IN THE DRAWINGS:

REMARKS

Ser. No.: 10/627,206
Inventor(s): Harry I. Ringermacher et al.
Attorney: P. Clarke
Telephone: (518) 387-5349

Fig. 9

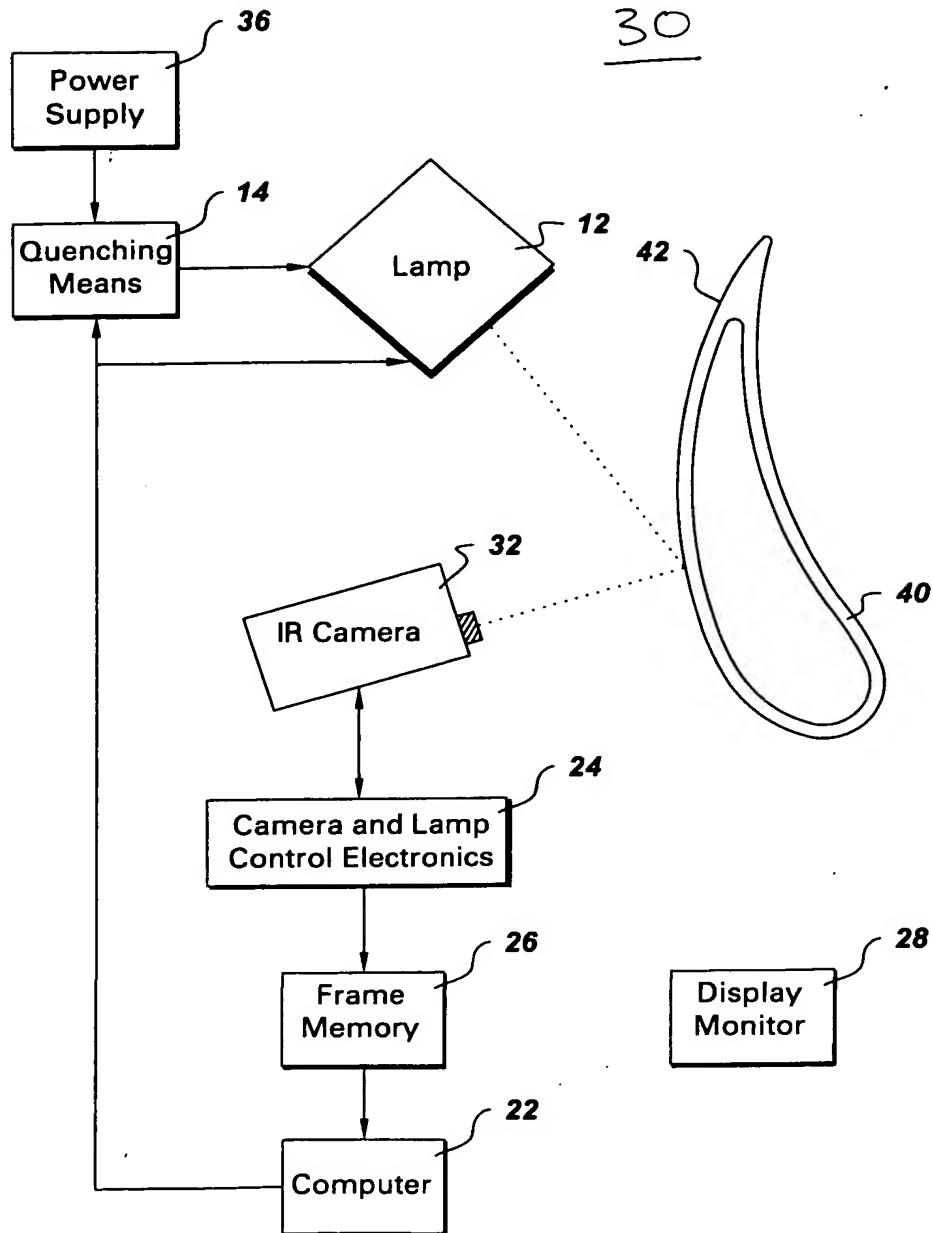
The attached drawing sheet includes changes to Figure 9. This sheet, which includes Figure 9, replaces the original sheet including Figure 9. In Figure 9, reference character 30 has been added to correspond with reference character 30 enumerated in the Specification.

As a preliminary matter, the specification was editorially revised to correct informalities without adding new subject matter. Figure 9 was amended to include inadvertently omitted reference character --30--.
